Response to Section 92 Request: Consent Application RM21.668 – Mt Cooee Landfill, Balclutha

Thank you for the Section 92 further information request we received on 27 July 2023 in relation to Clutha District Council's resource consent application RM21.668 to renew resource consents associated with the Mt Cooee Landfill in Balclutha.

Figure 1: Determining if a potential wetland on pastoral land passes the pasture exclusion test

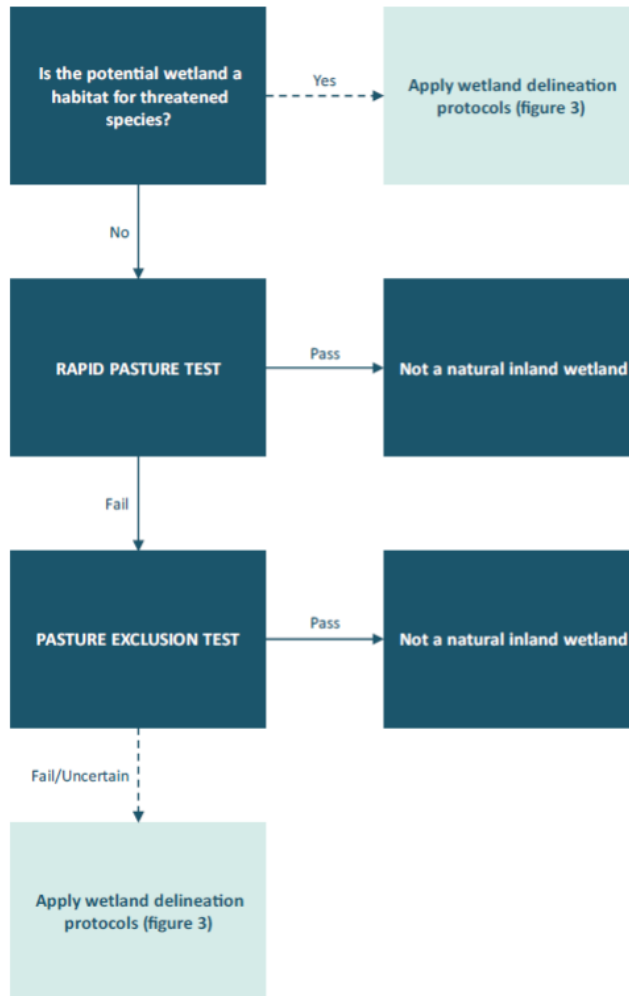
5. *Please provide evidence to demonstrate that the Wetland Delineation Protocols have been applied in the delineation of the wetlands to the south. The information requested includes the location of all sampling points and evidence that the necessary tools of the wetland delineation protocols have been used (vegetation, soils and hydrology tools as necessary).*

Note also that wetland delineation according to the Pasture Exclusion Methodology (MfE, 2022) should be completed during 'normal circumstances', not after intensive grazing.

Following MfE (2022a) and MfE (2022b)¹, a pasture exclusion test was applied to vegetation within the plots (Figure 1), followed by application of wetland delineation protocols to determine the presence of hydrophytic vegetation (Figure 2). Following these tests, there was no uncertainty regarding the presence of wetland vegetation with the plots either passing the pasture exclusion test or passing or failing the dominance and / or prevalence tests. As such, no further tests for hydrology or soils were required.

Figure 5: Hydrographic record for Mt Coee groundwater monitoring wells for the period 16th November 2022 to 17th August 2023.

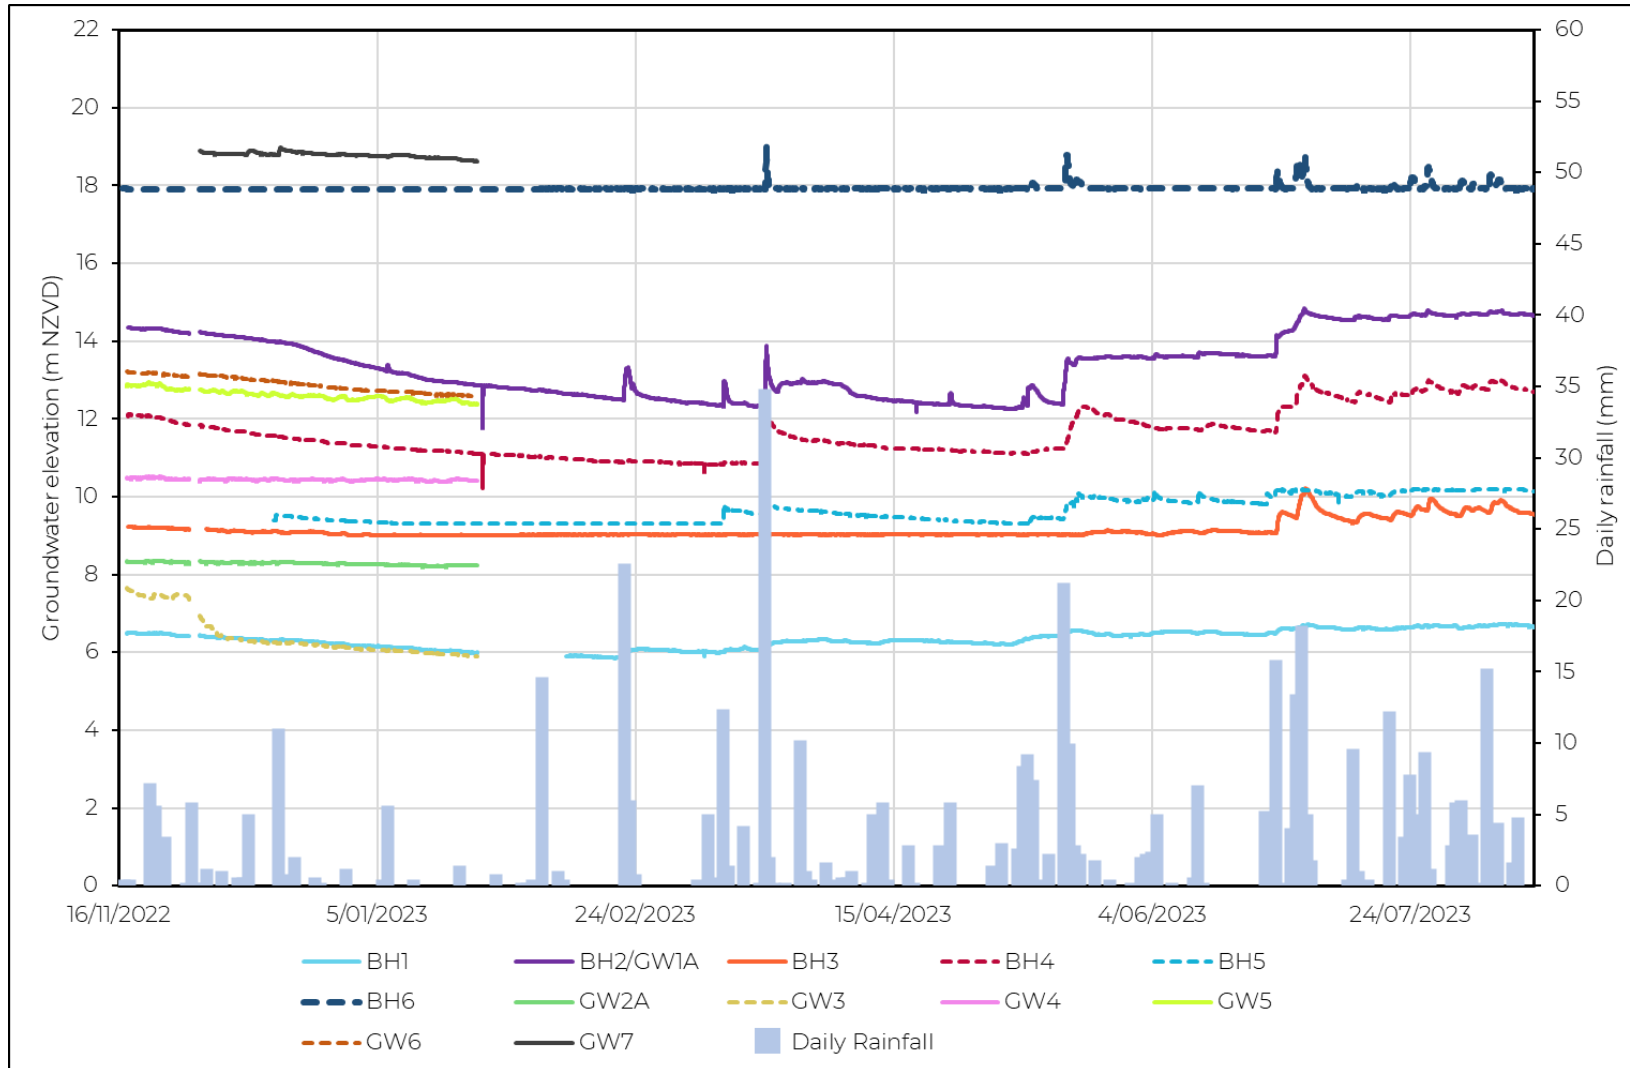
- Please undertake further continuous groundwater level monitoring within the 12 groundwater monitoring bores to show the full range of water level responses to different conditions of moisture saturation and leachate production.*

The updated groundwater monitoring record is provided in Figure 5 below. The monitoring record does show an increase in groundwater levels over the winter months.

Figure 6: An excerpt of Figure 12 from the consent application / AEE showing all activities will be at least 100m away from the two natural wetlands located on site.

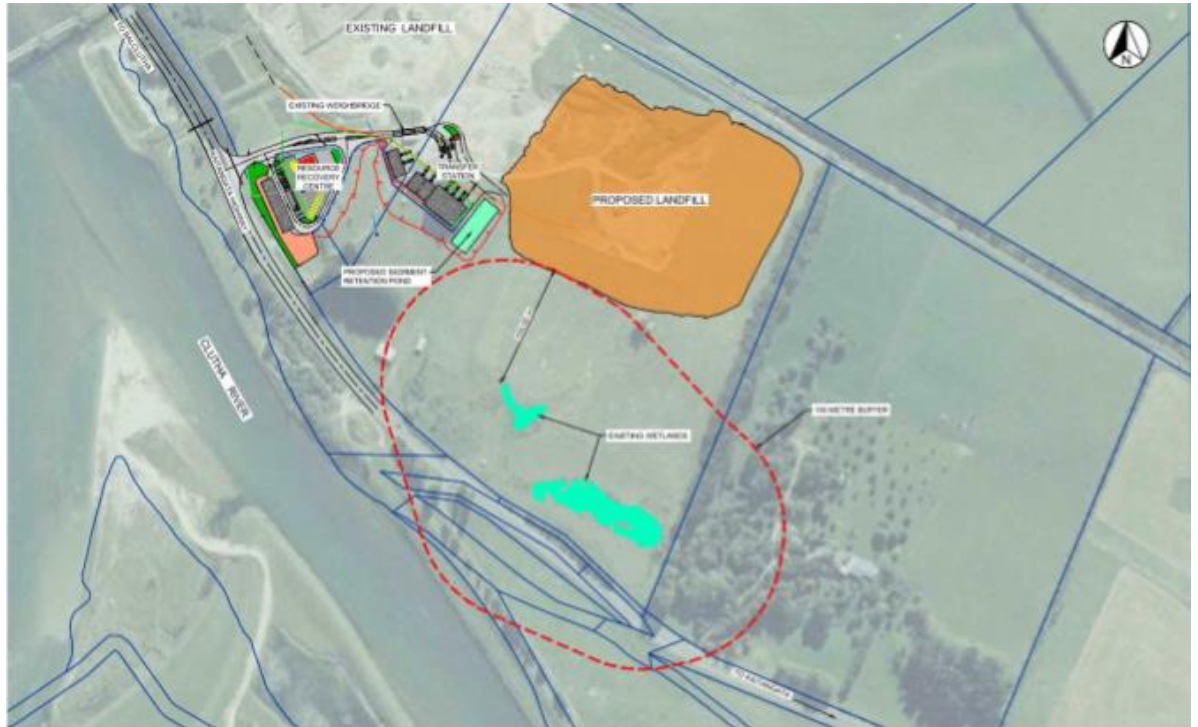
63. Please explain whether there will be any diversion of water, including stormwater, occurring within 100 m of the natural wetland? Taking into consideration your answer to question 5 of this request for information, please also confirm whether there will be any earthworks, vegetation clearance, groundwater take, or discharges within 100 m of the natural wetland areas.

We confirm that there will be no earthworks, vegetation clearance, groundwater take or discharges within 100m of the natural wetland areas on the landfill site, as per Figure 12 in the AEE (which is included below). Any stormwater that will be diverted within the site to the sediment retention ponds during the construction of the cells and then the operation of the landfill will be at least 100m away from the two natural wetlands.

There is a possibility that when the landfill is capped and remediated (i.e. grassed), stormwater runoff will discharge towards the wetlands as that is the original flow path (all stormwater would be considered clean and essentially rainwater). However, this will not be known until the Landfill Closure and Aftercare Plan is developed, and if a consent is required then, it will be sought by CDC.
